HICKS ROAD TRACT
PRELIMINARY MASTER PLAN
& SECTION
L.T. 556 19th DISTRICT, 2nd SECTION &
L.T. 16 17th 7, 2nd SECTION
COBB COUNTY, GEORGIA

PETITION NO: Z-77

Z-77 GREENFIELD PROPERTIES. LLC

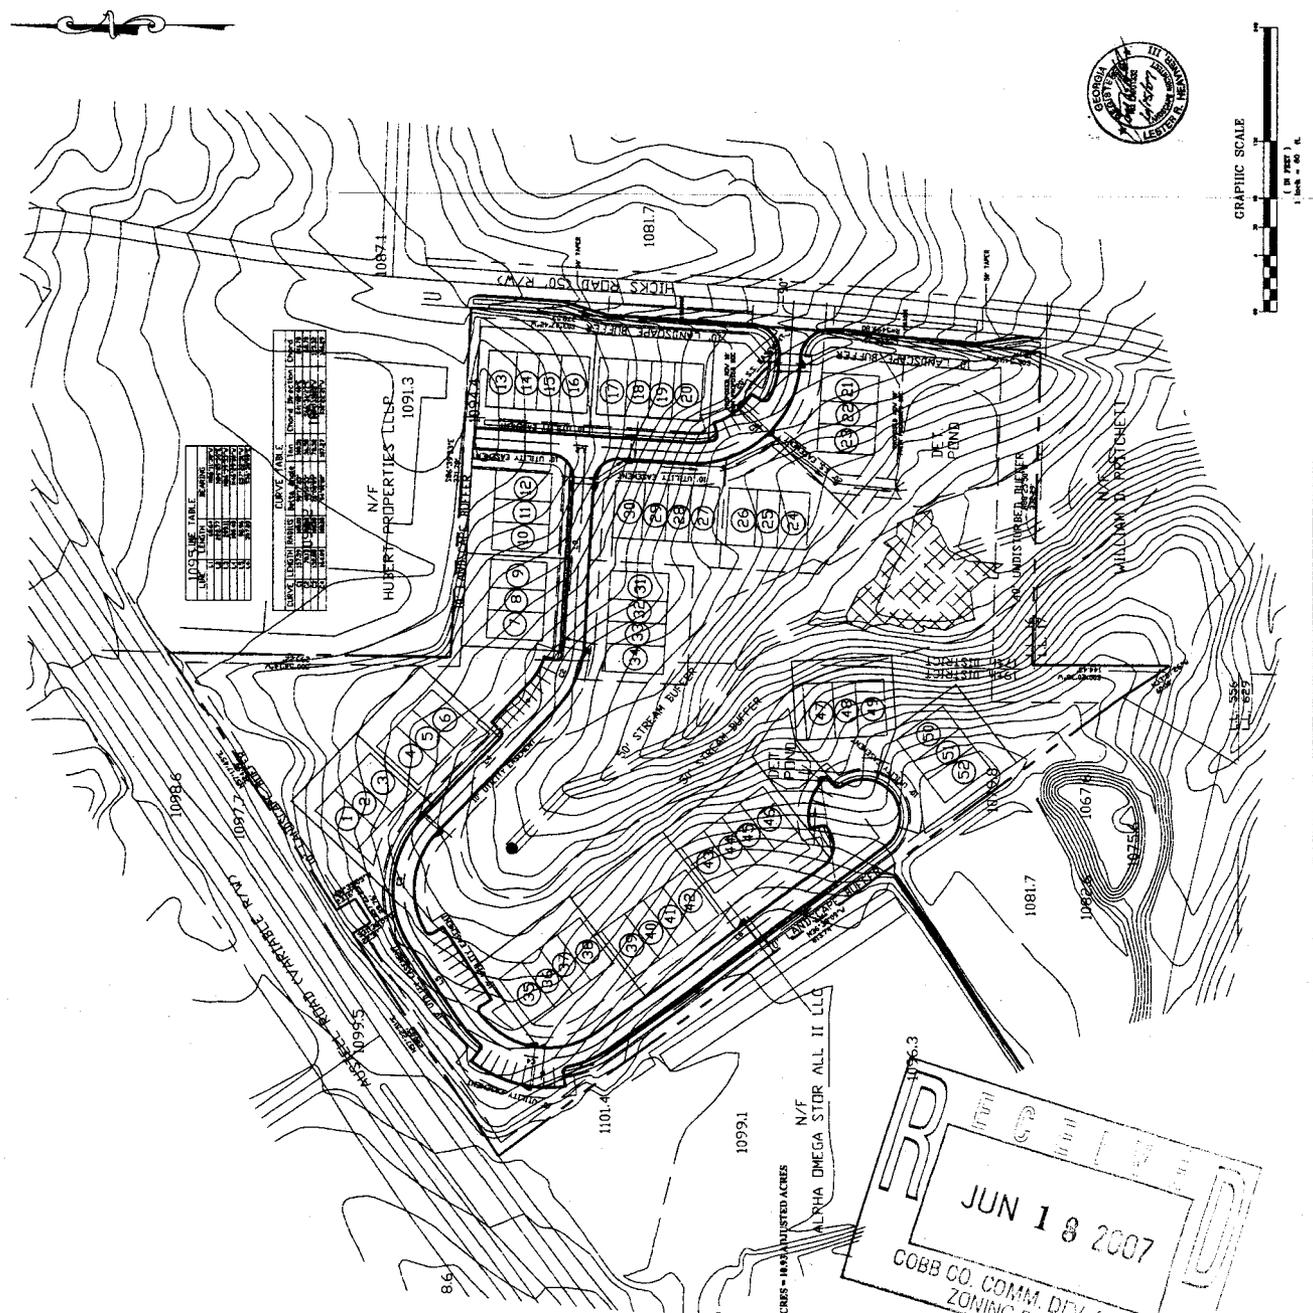
- Provide comprehensive hydrology/stormwater controls to include development of out parcels.
- Submit all proposed site improvements to Plan Review.
- Any **spring activity** uncovered must be addressed by a qualified geotechnical engineer (PE).
- Structural fill _____ must be placed under the direction of a qualified registered Georgia geotechnical engineer (PE).
- Existing facility.
- Project must comply with the Water Quality requirements of the CWA-NPDES-NPS Permit and County Water Quality Ordinance.
- Water Quality/Quantity contributions of the existing lake/pond on site must be continued as baseline conditions into proposed project.
- Calculate and provide % impervious of project site. **Maximum 75% impervious allowable in CAC.**
- Revisit design; reduce pavement area to reduce runoff and pollution.

- No Stormwater controls shown _____
- Copy of survey is not current - Additional comments may be forthcoming when current site conditions are exposed.
- No site improvements showing on exhibit.

1. Units 47 - 52 are located adjacent to steep slopes. These units should be constructed with drop foundations and grading limited to the building pads only.

- Site plan received by the Zoning Division June 18, 2007, with the District Commissioner approving minor modifications;
- Fire Department comments;
- Water and Sewer comments and recommendations;
- Stormwater Management comments and recommendations;
- DOT comments and recommendations;
- owner/developer to enter into a Development Agreement pursuant to O.C.G.A. §36-71-13 for dedication of system improvements to mitigate traffic concerns.
